Town of Parker Community Development Department
 Development Review Division
 Attention: **Julia Duncan**

Application Type: **Site Plan**
 Status: **First Referral**
 Application Name: Parker Pointe F1 AMD 1 L4A - Drive Through Coffee Shop
 Case/AP#: **SP24-128**
 Referral Received: January 3, 2025
 Comments Due: February 3, 2025

Review date: **January 15, 2025**

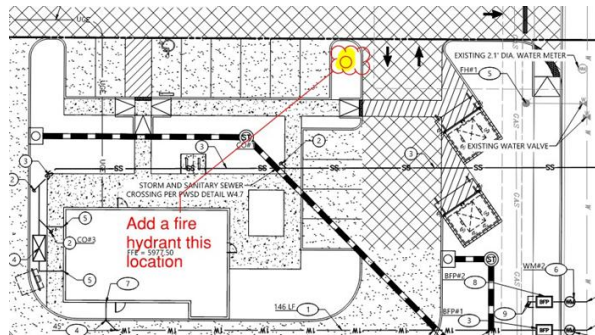
3. The applicant shall be aware that the access road hydrant distribution was not planned to address the suppression needs for all commercial properties within this subdivision; this site requires the addition of one fire hydrant (to be located at the s/e corner island located within 40 feet of the building... as required per NFPA 24 Section 7.2.3). The hydrant shall be located within 40 feet of the building be served with the hydrant located in the northeast island, as required per NFPA 24 Section 7.2.3. *Satisfied; the applicant has noted, acknowledged, or addressed with the second submittal.*

Commentary Figure 503.1.1(3) SMALL BUILDING ACCESS

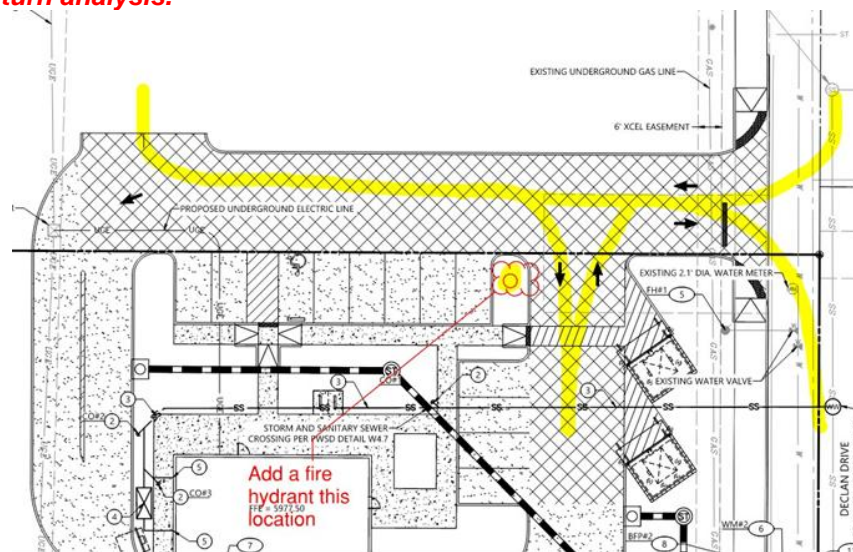
5. Per the requirements of the 2021 IFC Section 503.1.1, approved fire apparatus access roads shall be provided to for every facility such that the requirements of this section extend to within 150 feet of all facility and all portions of all exterior walls of the first story of the building as measured by an “approved route”. In the event that this cannot be achieved, the fire code official is allowed to increase that distance so long as the building is fully sprinklered per 903 of the 2021 IFC. While it appears that the applicant may be able to meet the requirements of the code, the applicant shall prepare and provide an exhibit that “proves that the access can be met. Please note, hose does not bend at 90 degrees and the applicant’s exhibit shall mimic the exhibit provided in the 2021 IFC Handbook. To aid the applicant with what this looks like, please see the following and address this issue when resubmitting (measurement shall be taken centerline of the access road on the north side of the lot. *Not satisfied; the applicant has not provided the information (although indicating that it has been provided). Note – this item cannot be verified as the applicant has not provided a revised site plan (though the applicant has provided a second “Core Electric Response named “Revised Civil Plan Set SUB 02). Satisfied, the applicant has addressed with the third submittal.*
